CITY OF ALBUQUERQUE

RE: Gyro Shack
4201 San Mateo Blvd. NE
30-Day Temporary CO - Approved
Engineer's Stamp Date: 11/01/22
Engineer's Certification Date: 8/14/24
Hydrology File: G17D024

GRADING & DRAINAGE PLAN

CG101

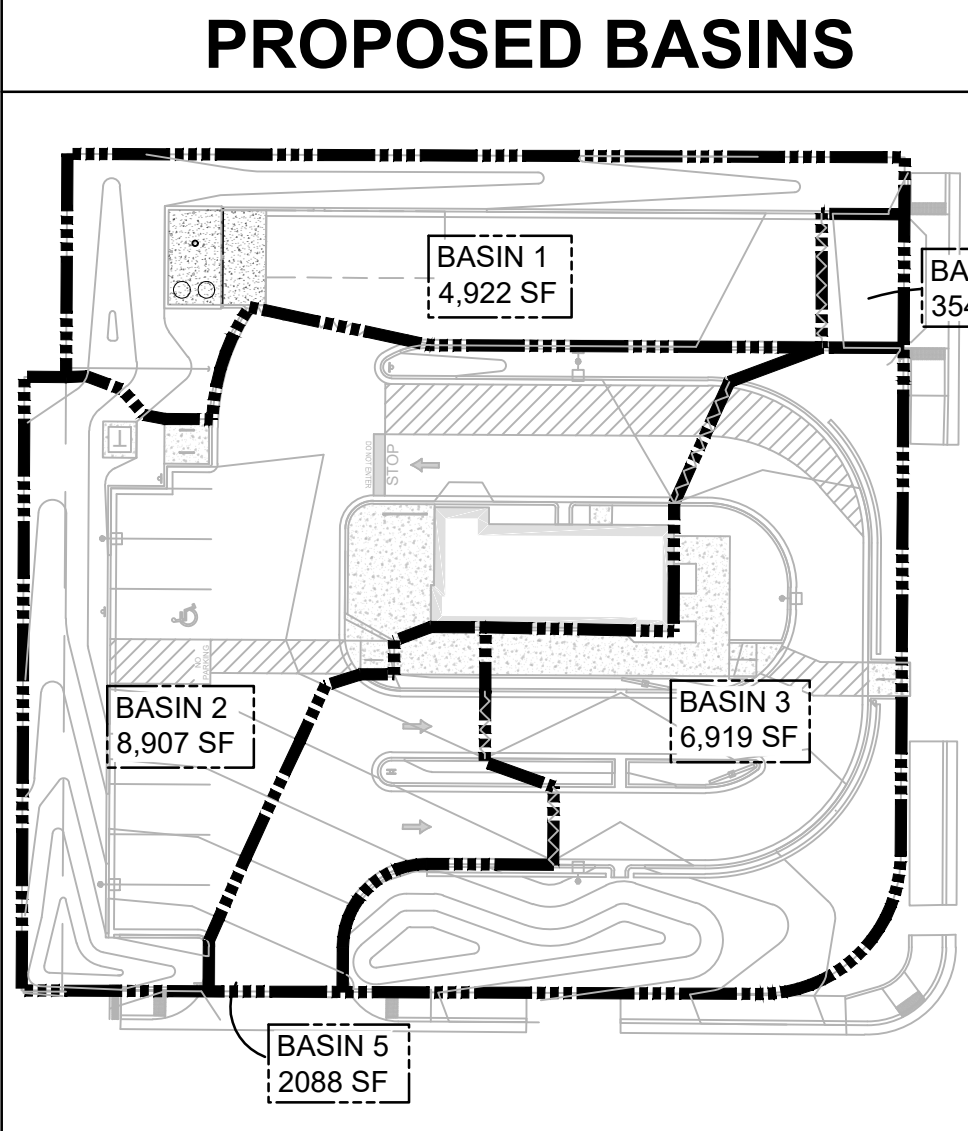
1. Please provide the executed paper Drainage Covenant (latest revision) printed on one-side only with Exhibit A and a check for **\$25.00** made out to "**Bernalillo County**" for the stormwater quality ponds per Article 6-15(C) of the DPM to Hydrology.
